Appl. No. 10/752,402
Response to OA dated March 5, 2007
Amendment dated April 26, 2007

PATENT
Docket No. 13067-004001
(J-CN4001)

Amendments to the Drawings

FIG. 1

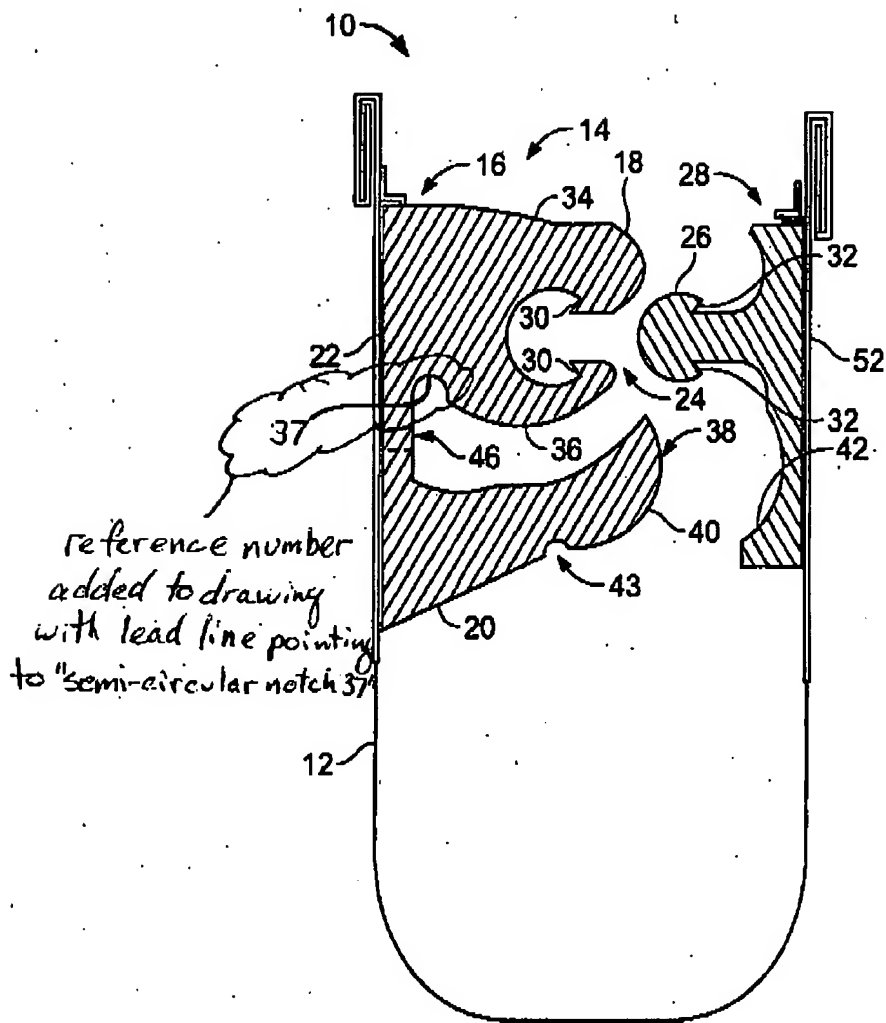
FIG. 1 has been amended to include reference number 37 and an appropriate lead line to the "semi-circular notch 37" at the base of the "inboard arm 36," as described in detail at page 6, line 27 of the specification . No new matter is presented hereby.
